## **Addendum #2**

### **RFP 10282022-157-01 Education Center Roof Replacement**

### **Questions, Answers, and Revisions**

**PARAPET**  
not to scale

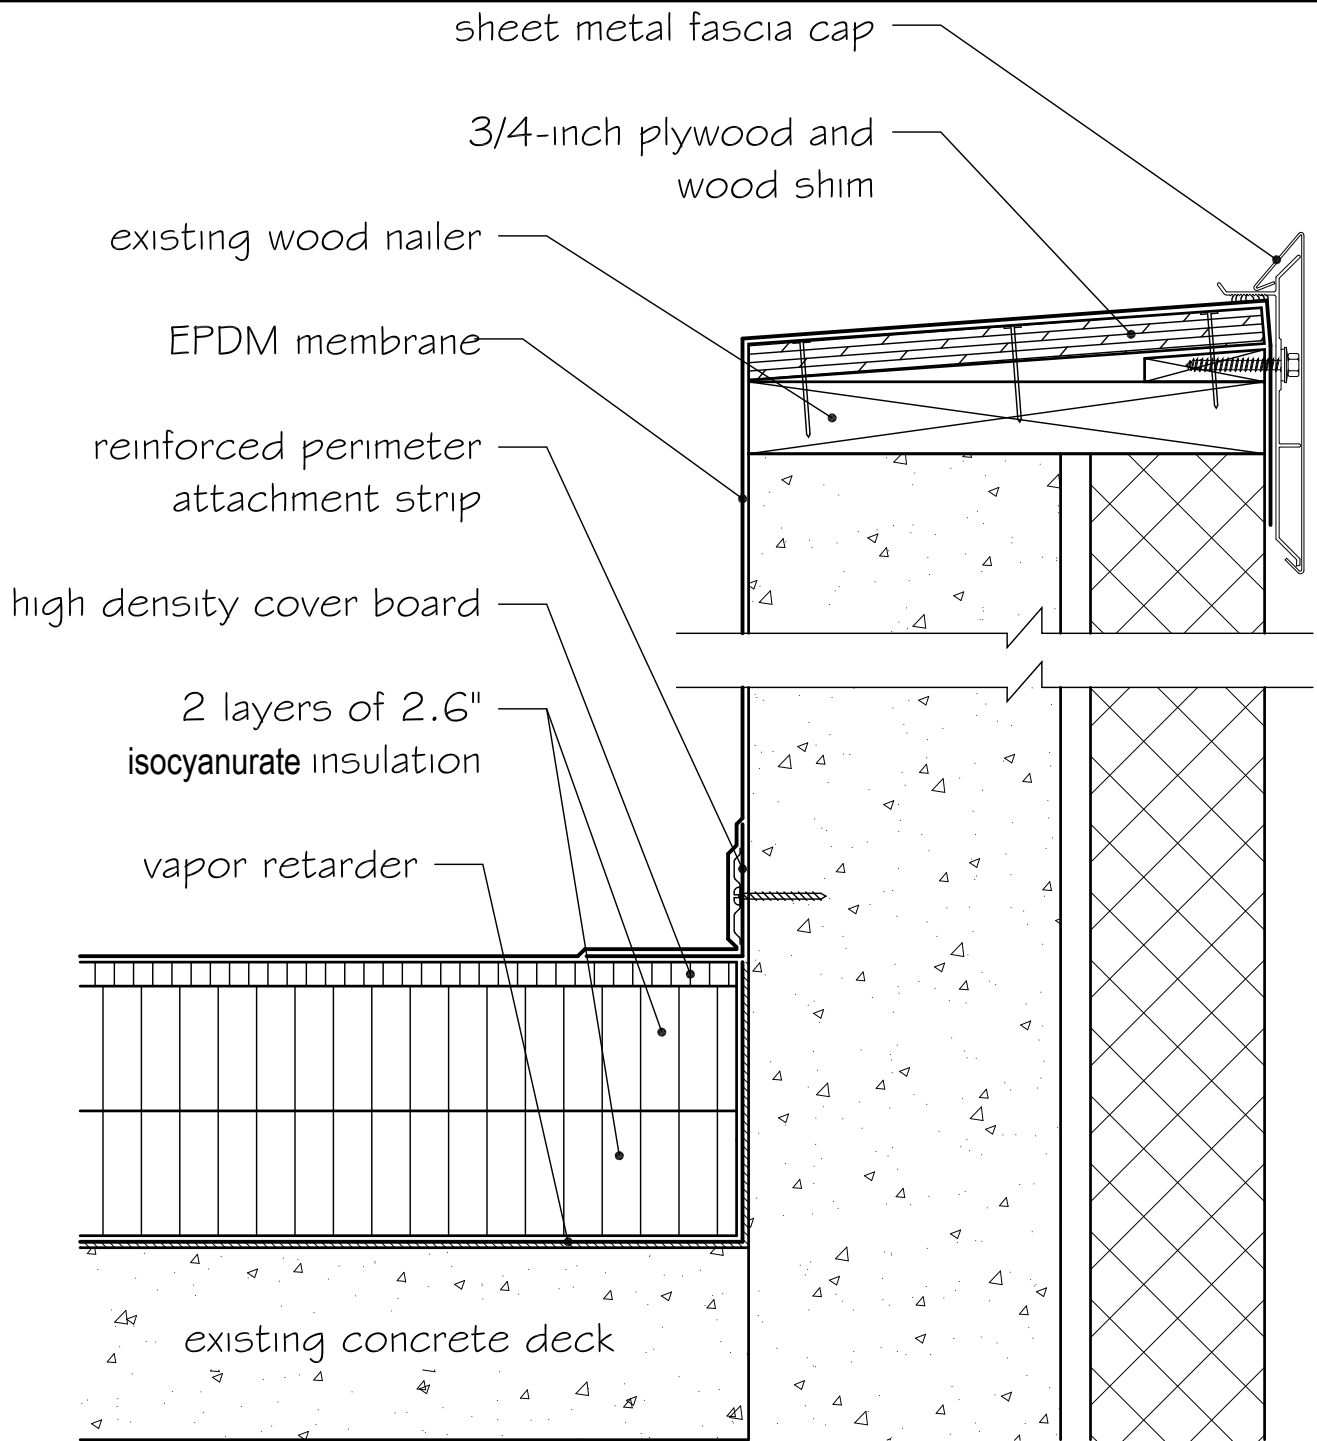
**Revision 1.** Revise Attachment #8, Detail No. 1 – Parapet: Delete “tapered isocyanurate insulation” note. Add “2 layers of 2.6-inch isocyanurate insulation” note. See attached page for Revision.

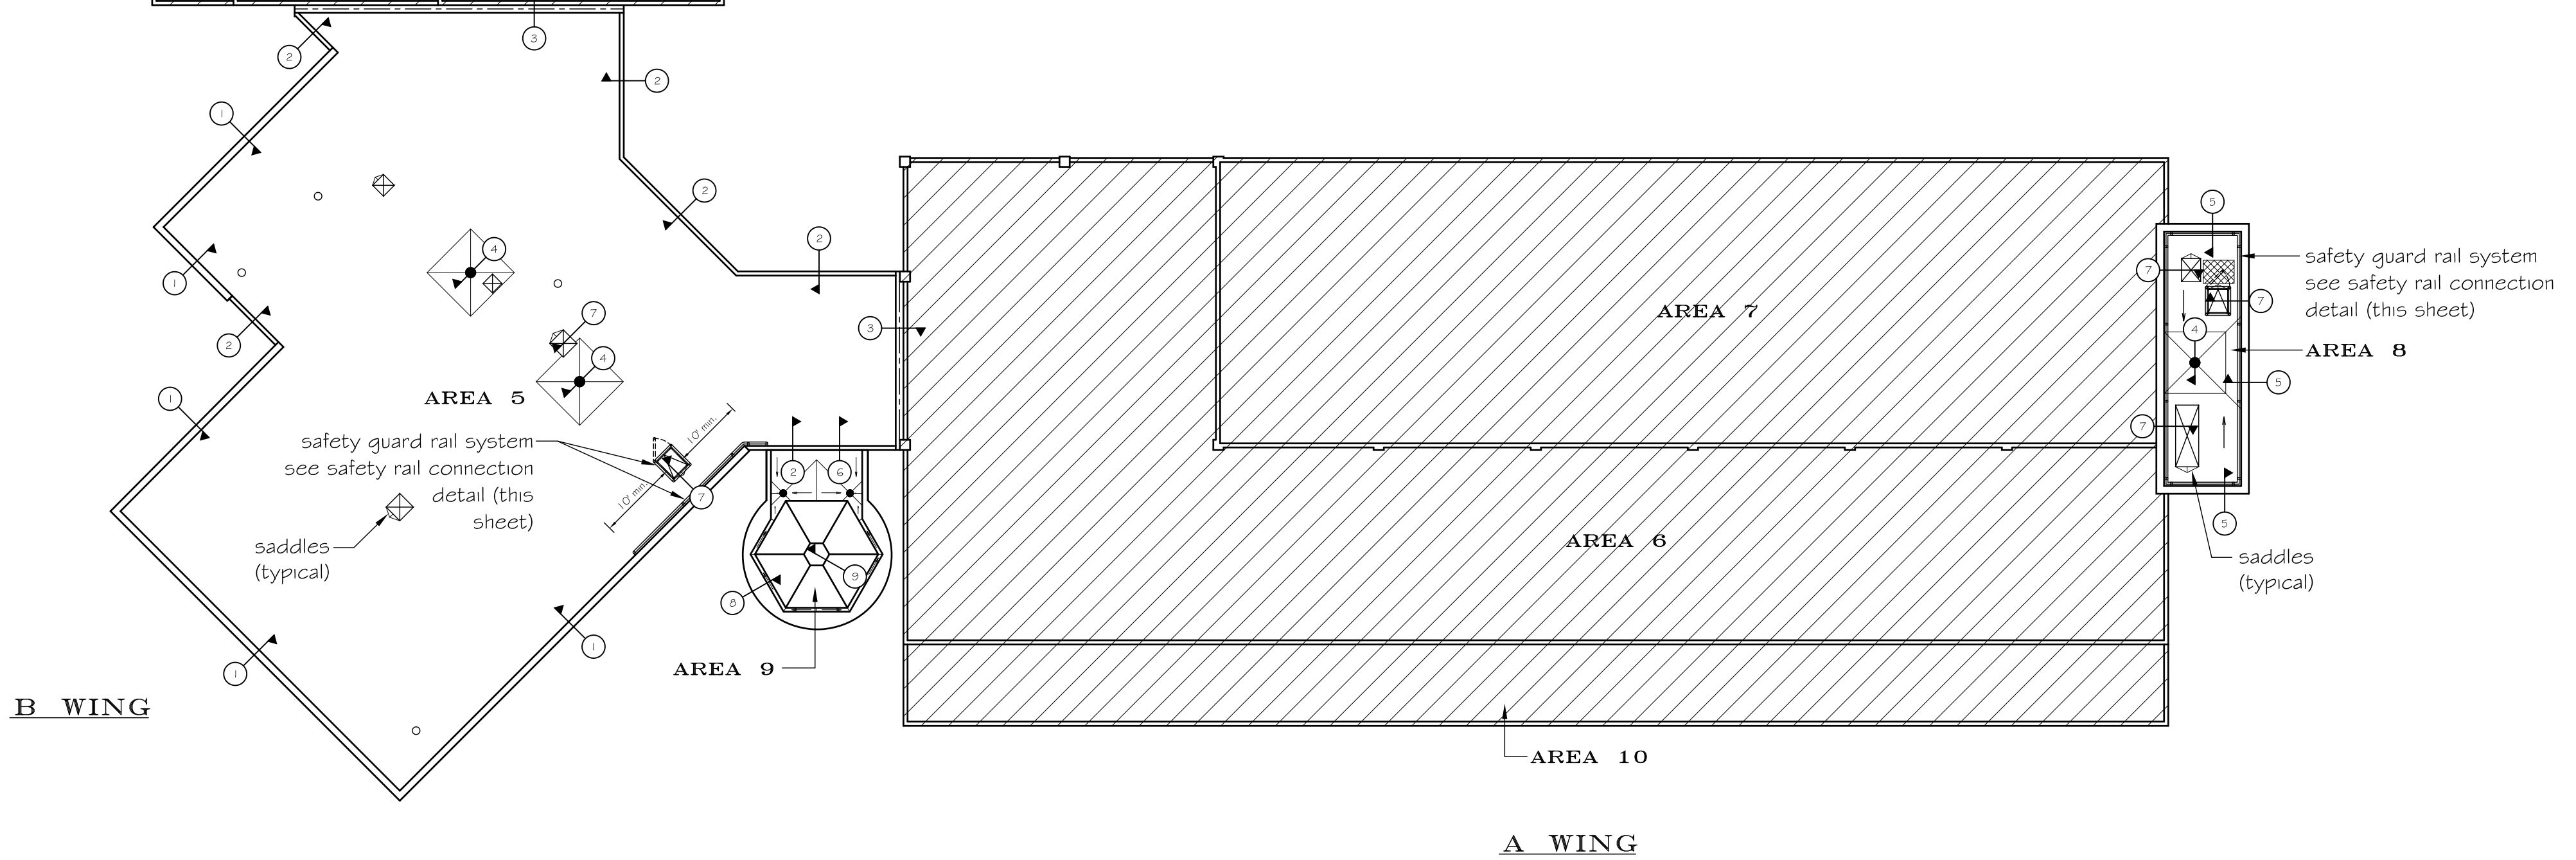
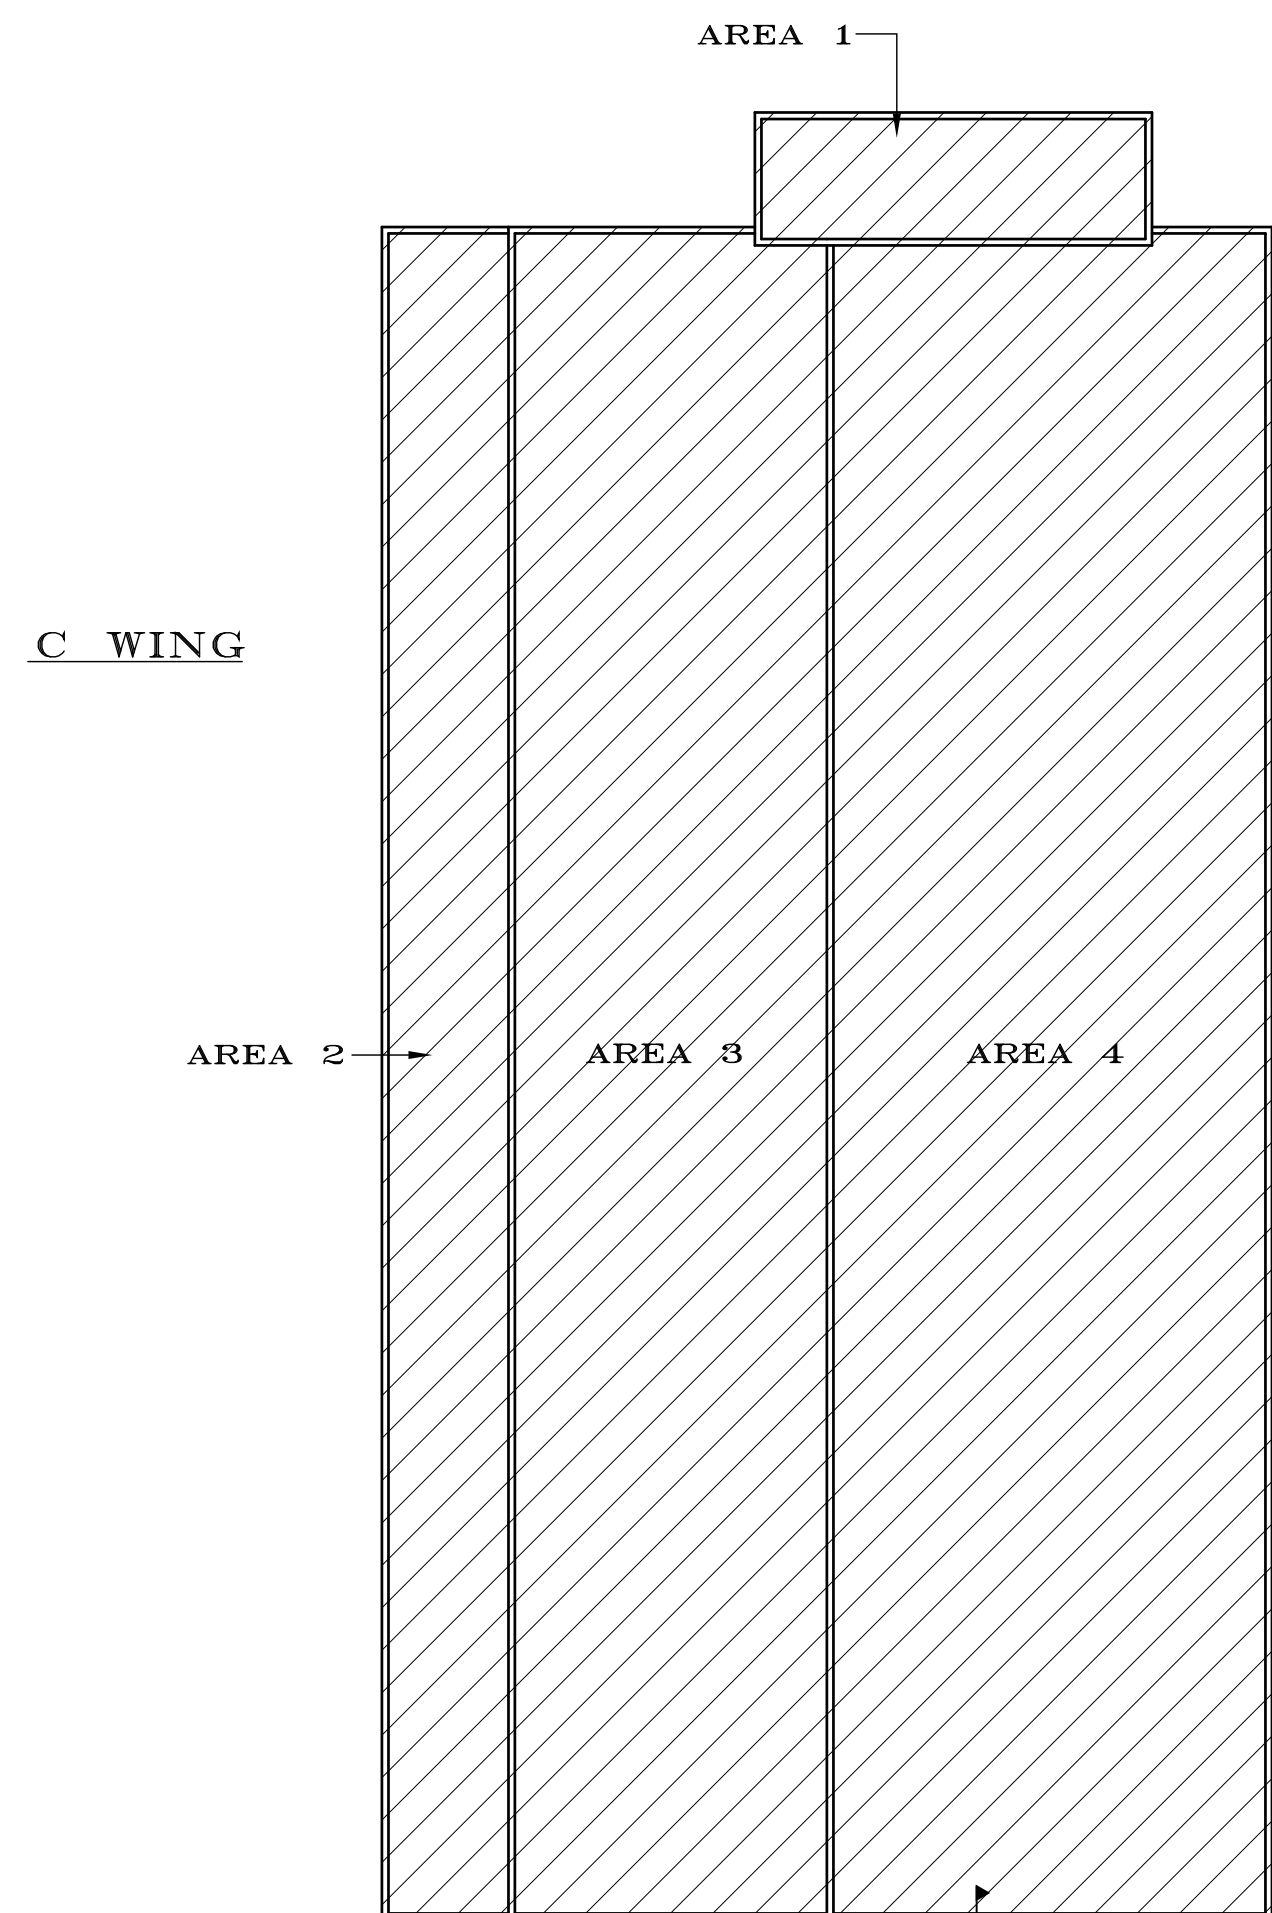
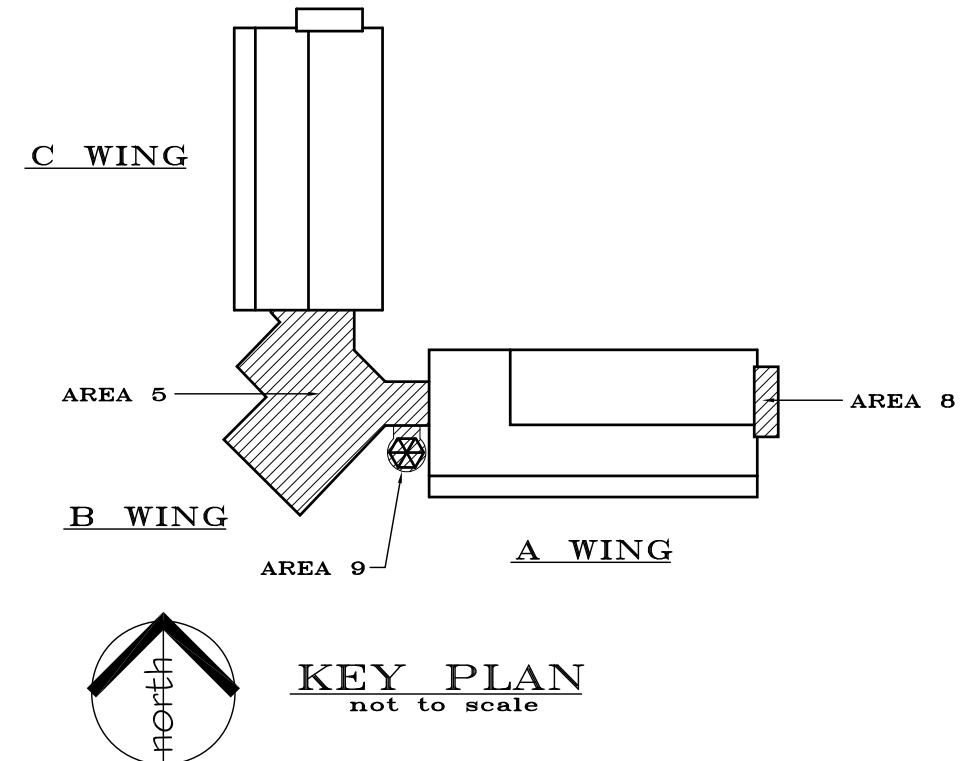
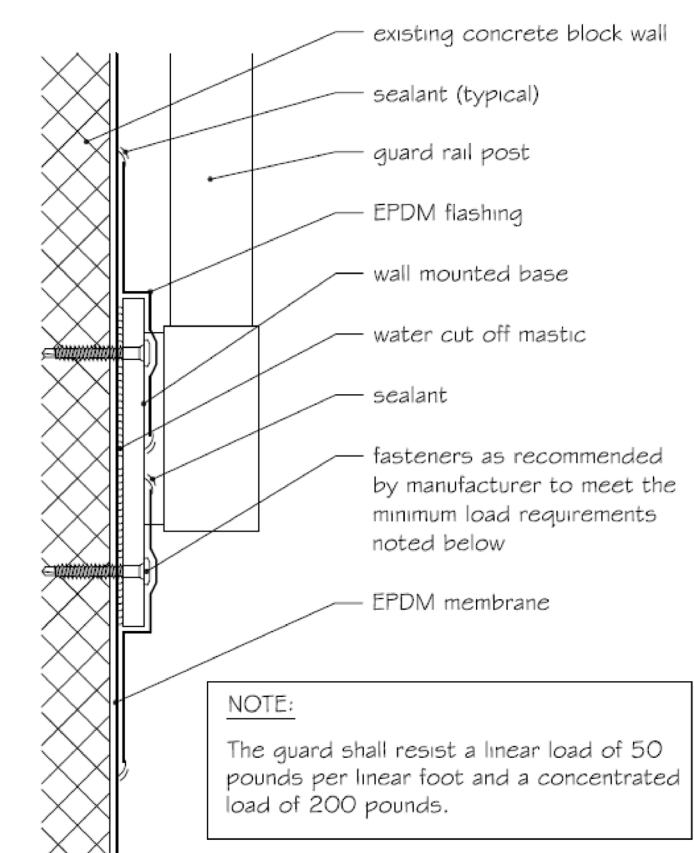
**Revision 2.** Revise Attachment #8, Plate No. 1 – Initial attachment illegible. See attached page for legible copy.
